# UNITED STATES PATENT AND TRADEMARK OFFICE

10/711,764

Toshiharu Furukawa

<b>Office Action Summary</b>	<b>Application No.</b>	<b>Applicant(s)</b>	
	10/711,764	FURUKAWA ET AL.	
	<b>Examiner</b>	<b>Art Unit</b>	
	Jarrett J. Stark	2823

FIG. 9

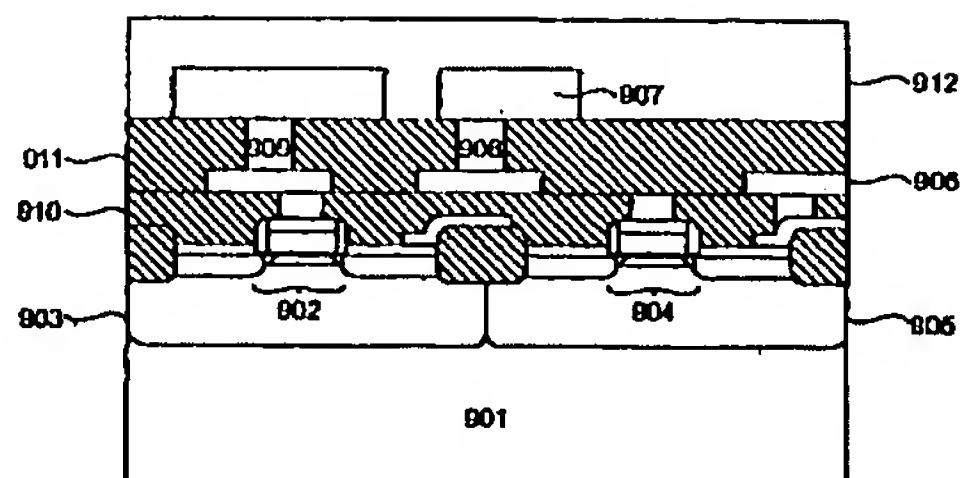
**Regarding claim 7,** Dahl discloses the dielectric material of claim 1 further comprising a cap layer on said dielectric material (Dahl Figure 9 & ¶ [0139] – dielectric layers are [910 & 911] and capped with layers [907 & 912]).

at least one conductive feature in said dielectric layer, said at least one conductive feature electrically isolated from nearby conductive features by portions of said dielectric layer (Dahl Figure 9 & ¶ [0139]).

a cap layer of an insulating material at least partially covering said exposed surface, said cap layer having a top surface, and said conductive feature having a top surface substantially coplanar with said top surface of said cap layer (Dahl Figure 9 – [910 & 911] → Dielectric layer, [907] → interconnect & [912] → passivation layer).

**Regarding claim 16,** Dahl discloses the semiconductor structure of claim 11 wherein said structure comprises a plurality of conductors electrically isolated by said layer of said dielectric material (Dahl Figure 9 – [910 & 911] → Dielectric layer, [907] → interconnect & [912] → passivation layer).

**Regarding claim 18,** Dahl discloses the semiconductor structure of claim 11 further comprising: a cap layer disposed on said fluorinated carbon nanostructures (Dahl Figure 9 – [910 & 911] → Dielectric layer, [907] → interconnect & [912] → passivation layer).

a substrate selected from the group consisting of an interconnect level, a dielectric material, a buried barrier layer, a metallization line, and a semiconductor wafer (Dahl Figure 9 – [910 & 911] → Dielectric layer, [907] → interconnect & [912] → passivation layer).

conductive feature being electrically coupled with at least one of said circuit elements  
(Dahl Figure 9 – [910 & 911] → Dielectric layer, [907] → interconnect & [912] →  
passivation layer).
